Access Compliance Report

Public Rights-of-Way

Intersection ID: 49895	Main Street: FERRELL_COMMONS_RD	Cross Street: PROSPERITY_COMMONS_DR	Location: NW
ADA ID: E48FE609C073	Ramp Type: PerpDiag	Initial Pass/Fail: Fail	Overall Compliance: No
		Severity Score: 25

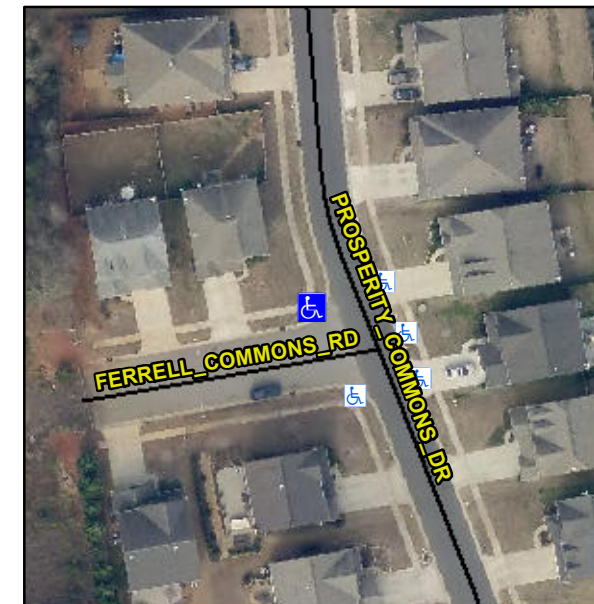
Not Found, R304.5.3

Compliance	Description	Data	Compliance	Description	Data
N/A	Ramp Length (in)	74.0	Yes	Ramp Slope (%)	6.1
Yes	Ramp Width (in)	48.0	No	Ramp XSlope (%)	8.1
N/A	Flare Type LT	N/A	N/A	Flare Type RT	N/A
N/A	Flare Slope LT (%)	N/A	N/A	Flare Slope RT (%)	N/A
N/A	Flare Traversable LT?	N/A	N/A	Flare Traversable RT?	N/A
N/A	Landing Length (in)	N/A	N/A	DWS Provided?	N/A
N/A	Landing Width (in)	N/A	N/A	DWS Contrast?	N/A
N/A	Landing Slope (%)	N/A	N/A	DWS Length (in)	N/A
N/A	Landing X Slope (%)	N/A	N/A	DWS Full Width?	N/A
N/A	Landing Curb? (Y/N)	N/A	N/A	DWS Offset (in)	N/A
N/A	Shared Landing?	N/A			
N/A	Gutter Ponding?	N/A	N/A	Gutter Slope (%)	N/A
N/A	Gutter Lip Ht (in)	N/A	N/A	Gutter X Slope (%)	N/A
N/A	Painted X Walk1?	No	N/A	Painted X Walk2?	No
	X Walk 1 Direction	To S		X Walk 2 Direction	To E
N/A	X Walk 1 Width (in)	N/A	N/A	X Walk 2 Width (in)	N/A
	X Walk 1 Slope (%)	1.7		X Walk 2 Slope (%)	0.3
	X Walk 1 X Slope (%)	5.0		X Walk 2 X Slope (%)	2.5

Remove & Replace Curb Ramp With Two New Directional Ramps or Equivalent.
